ADDENDUM

No. 02 Date: 9/5/2024
Project No. 0020711.01 Attention: Leonard D'Souza
Project Name: Princess Margaret Cancer Centre
Stem Cell Transplant 2, MHC, MHDU, DSC
Address: University Health Network
610 University Avenue
Toronto ON

Project Name:	UHN PM Stem Cell Transplant Phase II Part A	Date Issued:	September 5, 2024
Quasar Project #:	HC-21-058		
Distribution			
Cannon Design Ltd.	Linda Vela	lvela@cannondesign.com	
Cannon Design Ltd.	Jennifer Huynh	jhuynh@cannondesign.com	
Quasar Consulting Group	Alexandra Blagojevic	alexandra.blagojevic@quasarcg.com	
Quasar Consulting Group	Jerry Guidarelli	jerry.guidarelli@quasarcg.com	
Quasar Consulting Group	Jomuel Estranero	jomuel.estraneo@quasarcg.com	
Quasar Consulting Group	Manda Bobinac	manda.bobinac@quasarcg.com	
Addendum #:	M-1		
Revision #:	0

Project Name:	UHN PM Stem Cell Transplant Phase II Part B	Date Issued:	September 5, 2024
Quasar Project #:	HC-21-058		
Distribution			
Cannon Design Ltd.	Linda Vela	lvela@cannondesign.com	
Cannon Design Ltd.	Jennifer Huynh	jhuynh@cannondesign.com	
Quasar Consulting Group	Alexandra Blagojevic	alexandra.blagojevic@quasarcg.com	
Quasar Consulting Group	Jerry Guidarelli	jerry.guidarelli@quasarcg

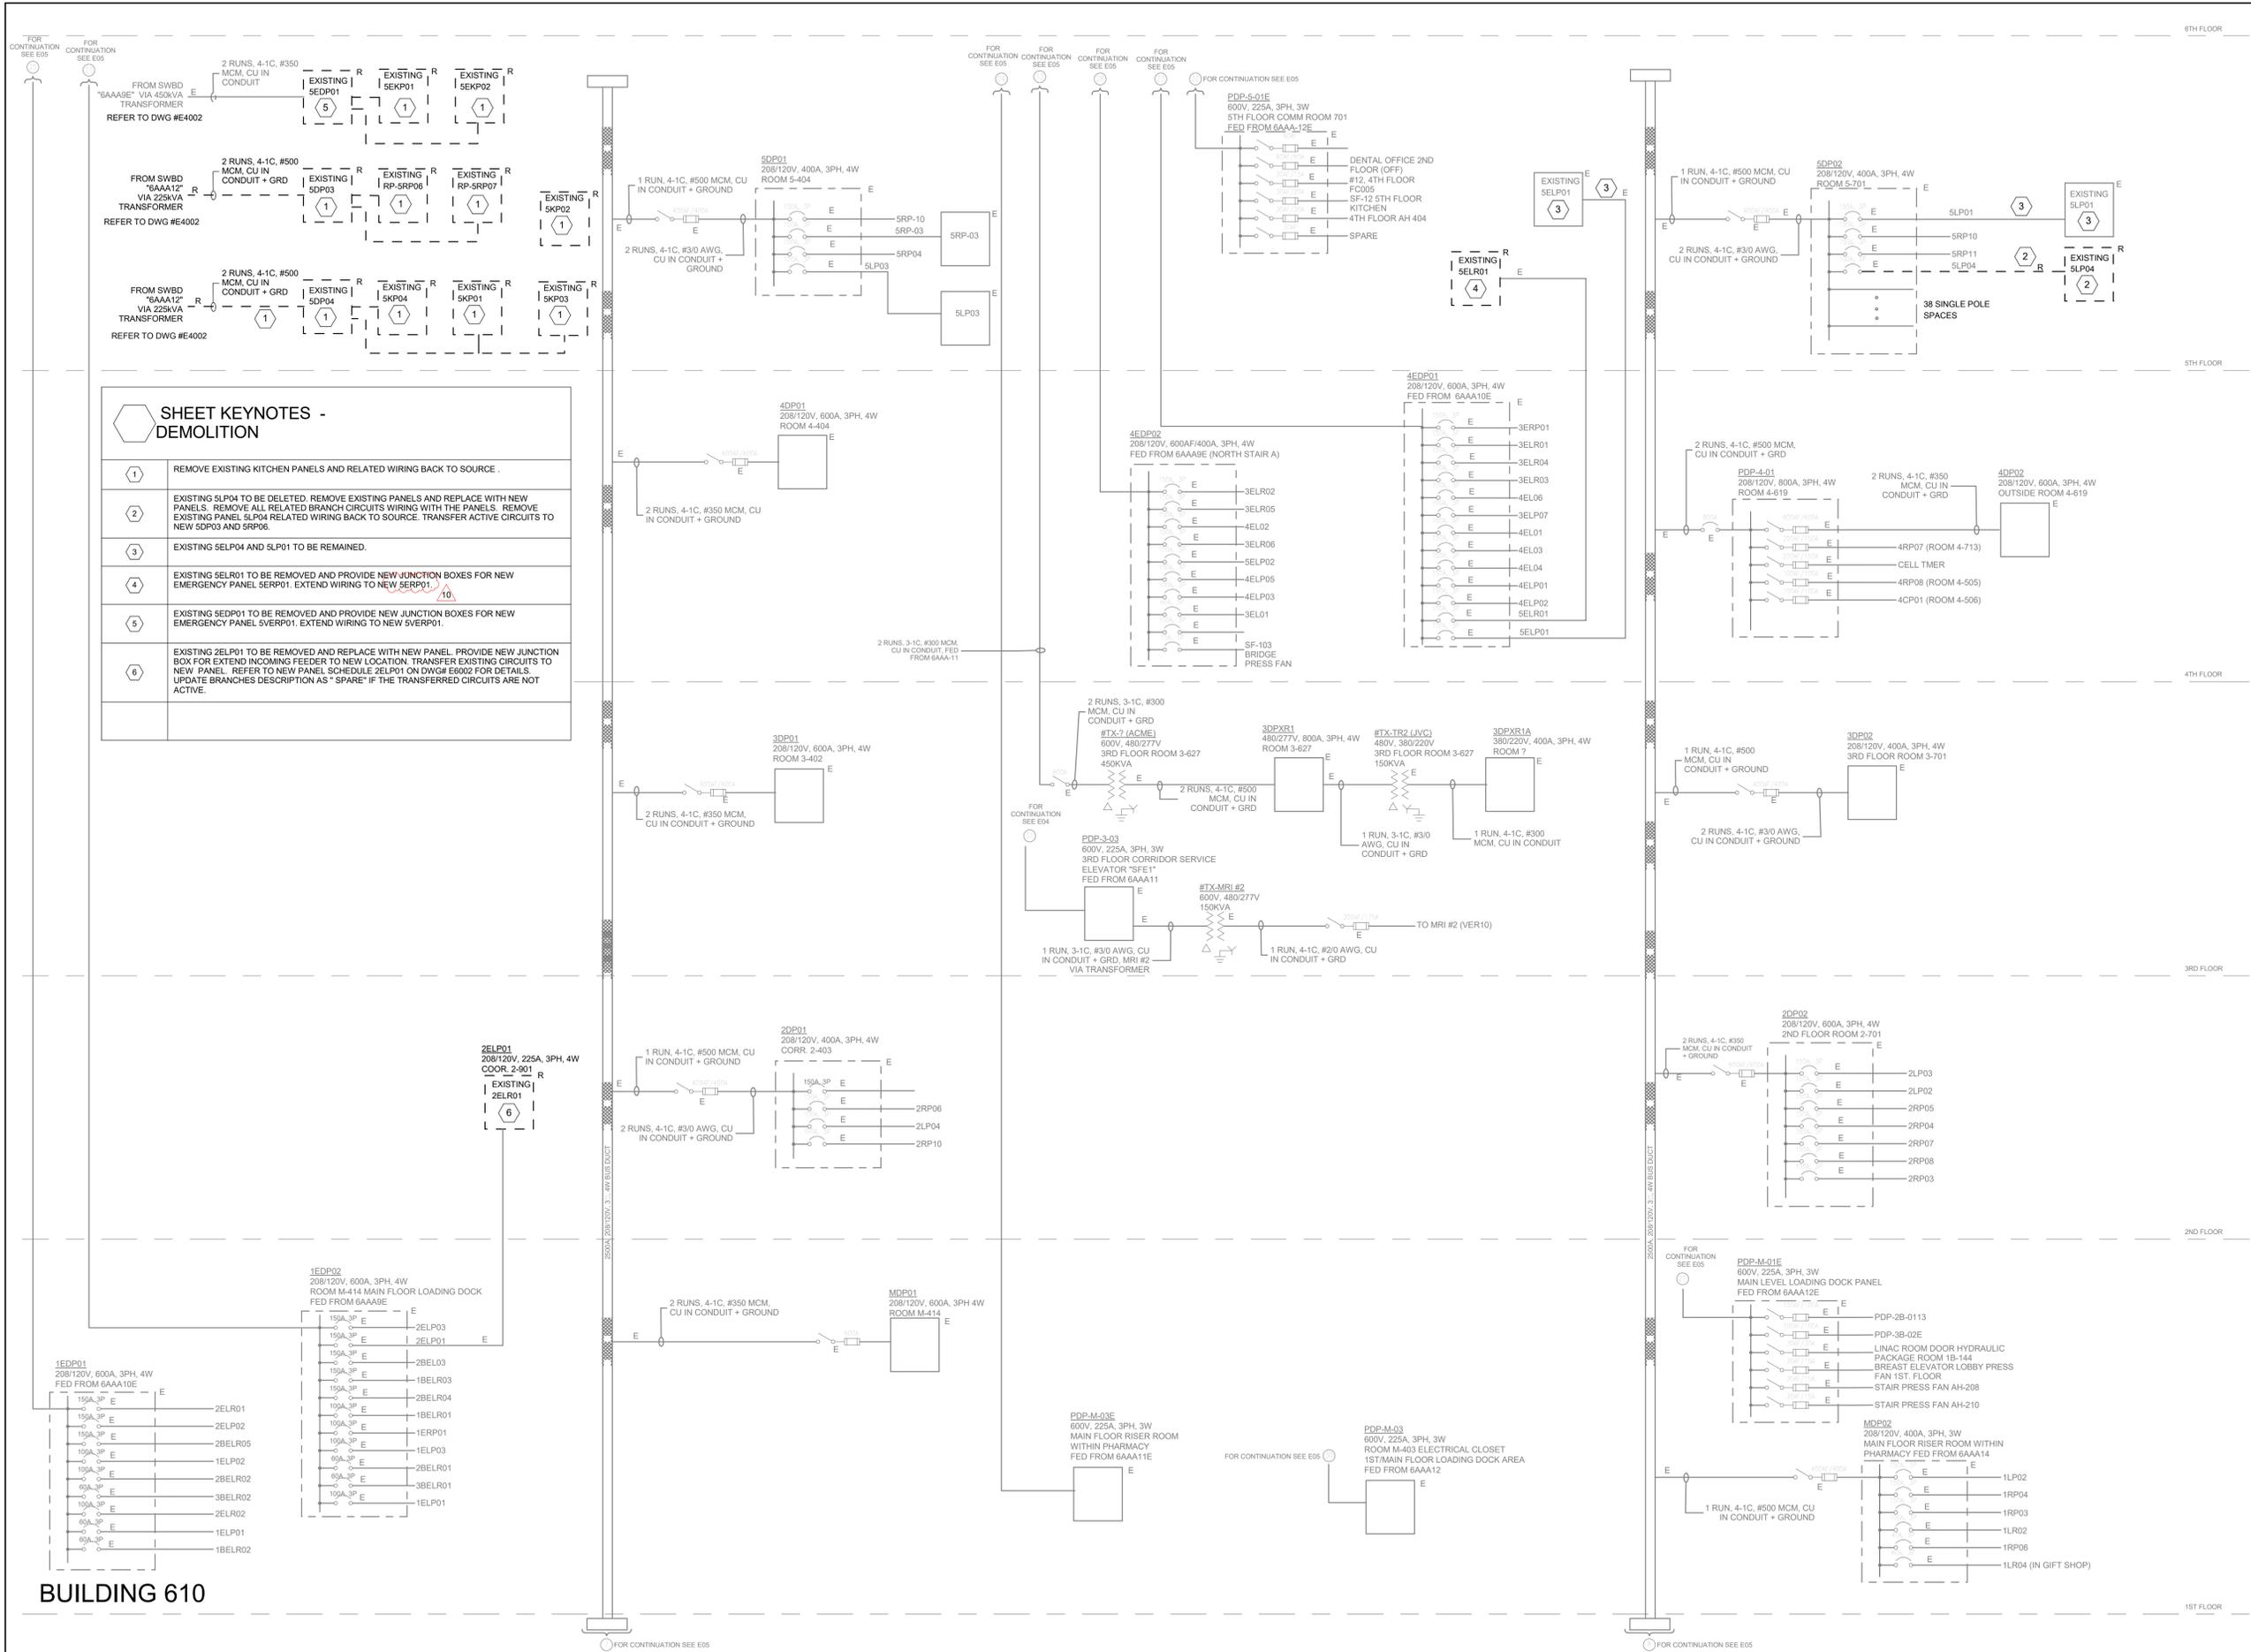
1. (46) Reference is made to drawing# E4106 & E4102 & E4002- - The source for panel 5ERP01 is not matching with what is shown on the single line diagram E4102 and the note#5 on drawing E4002.

QCG E: (46) The Drawings has been reviewed and E4106 has been revised to the proper source for 4EDP01 which is the source panel for 5ERP01. Lastly, Revised DWG # E4002 key note #4 new panel name "5VERP01" to "5ERP01". Refer to updated E4002 issued as part of Addendum E-1.

E4102

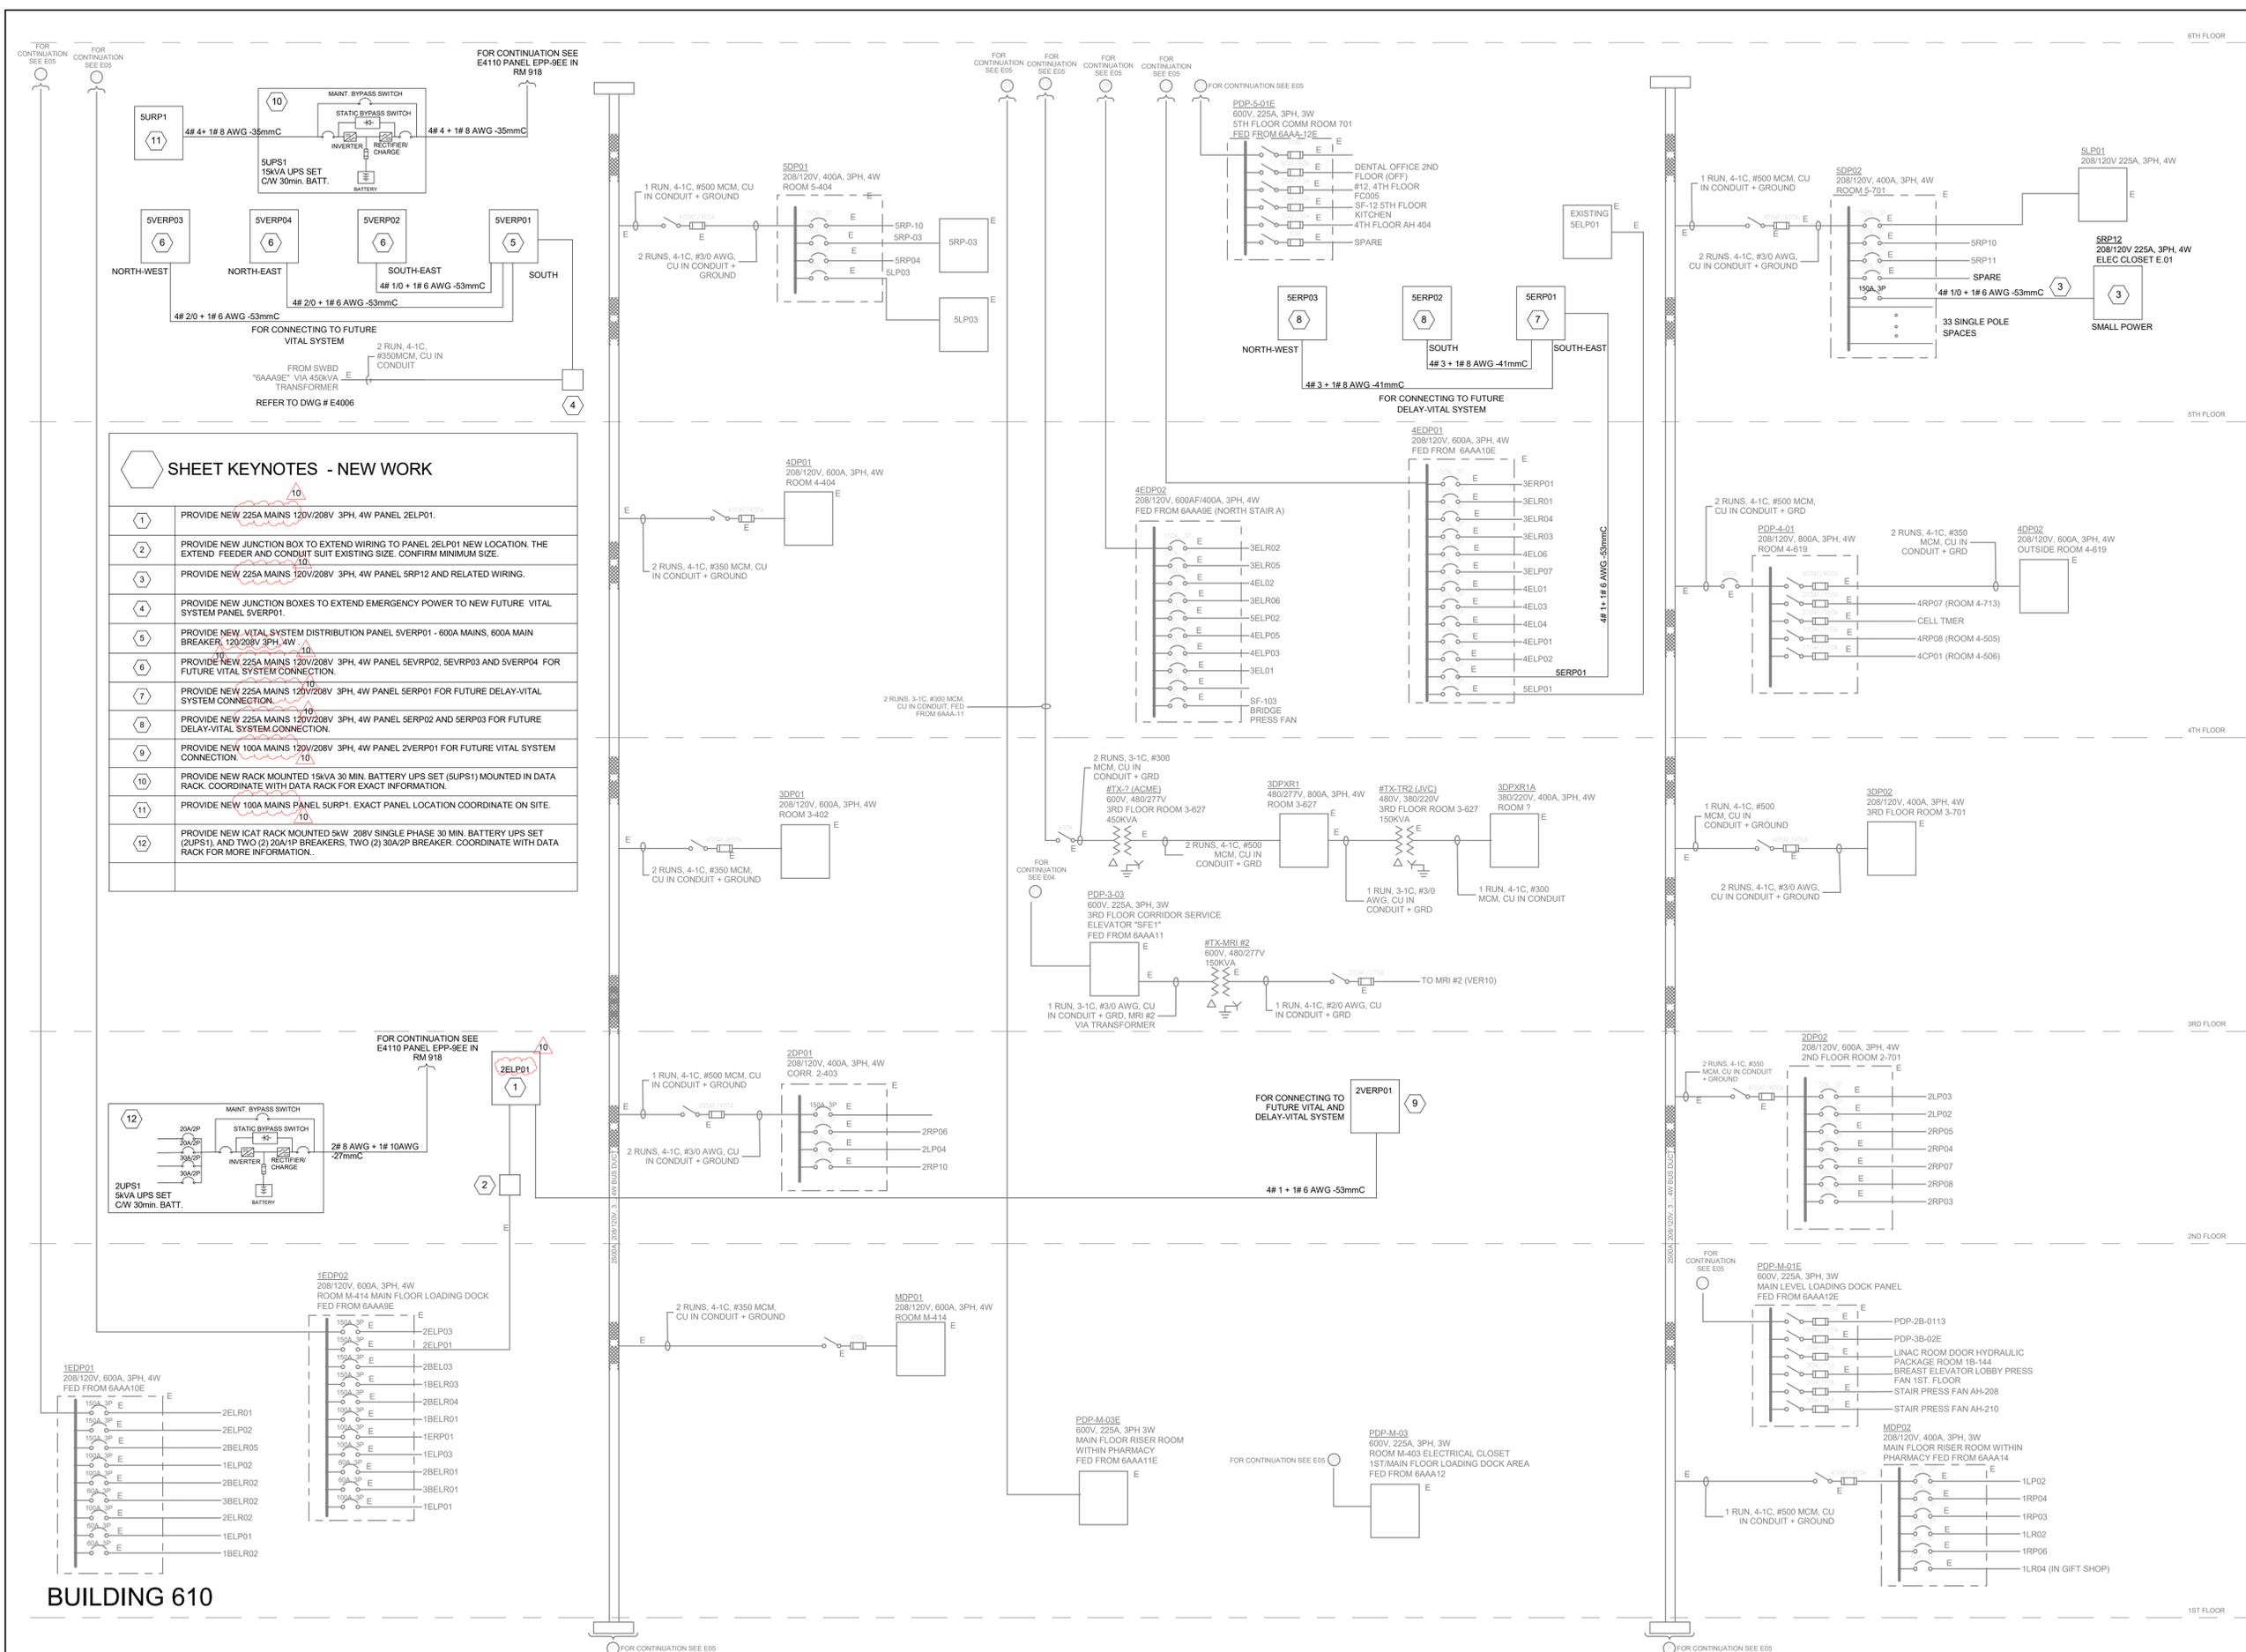
5. (50) Drawing #E4102- As per note#1- we assume Panel 2ELR01 is to be tagged as 2ELP01. Please revise

23. (110) Some panel schedules such as for panels 5ERP01, 5ERP02, 5ERP03 are not matching with the notes (42 cct panels instate of 84cct) on single line diagram E4102. Suppliers/Manufactures use panel schedules for pricing electrical panels. Please clarify if the panel schedules need any revisions

QCG E: (50) The Comment has been reviewed and E4102 has been revised and "2ELR01" has been updated to "2ELP01"on the single line diagram, note 1 is correct. Refer to updated E4102 issued as part of Addendum E-1.

QCG E: (110) Panel Schedules are correct, notes on SLD will be revised to remove number of circuits, refer to panel schedule for total number of circuits. RevisedE4102 will be reissued as part of Addendum E1.
